Detailed Site Plan **DSP-95063-09**
Departure from Design Standards **DDS-675**
Alternative Compliance **AC-09008-01**
The Children's Guild (St. John Baptist de la Salle)

REQUEST	STAFF RECOMMENDATION
DSP: Addition of a 5,524-square-foot modular classroom building to the existing school and increase the total student enrollment to 190 students.	APPROVAL with conditions
DDS: A reduction in the requirements of the 2010 <i>Prince George's County Landscape Manual</i> .	APPROVAL
AC-09008-01: Section 4.7, Buffering Incompatible Uses	DISAPPROVAL

STAFF REPORT

SUBJECT: Detailed Site Plan DSP-19058
Departure from Design Standards DDS-675
Alternative Compliance AC-09008-01
The Children's Guild (St. John Baptist de la Salle)

MODULAR BUILDING DETAILS
NTS

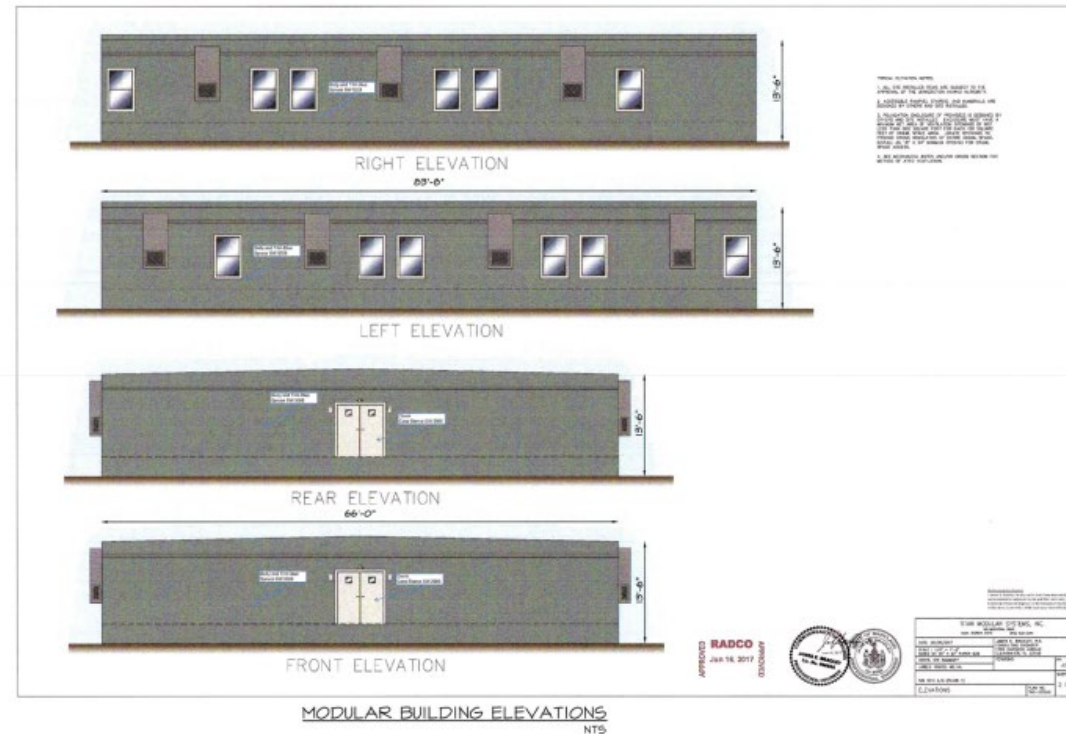
The applicant is proposing additional site and building-mounted lighting on the proposed modular building and near the walkways on-site. The details and specifications for the lighting show a downward facing light fixture with a 20-foot-high pole. Due to the location of the proposed site and building-mounted lighting, staff recommends that the light pole be reduced to 15 feet in height and that a photometric plan be submitted with the DSP. The photometric plan should show appropriate lighting levels with a balanced pattern on the property and not cause glare onto the adjoining residential properties. Therefore, conditions have been included herein requiring the applicant to reduce the height of the pole-mounted lighting, clearly label its location on the site plan, and provide a photometric plan, showing adequate lighting levels on the property.

d. Reduce the height of the proposed pole-mounted lighting to 15 feet and clearly indicate their location on the site plan.
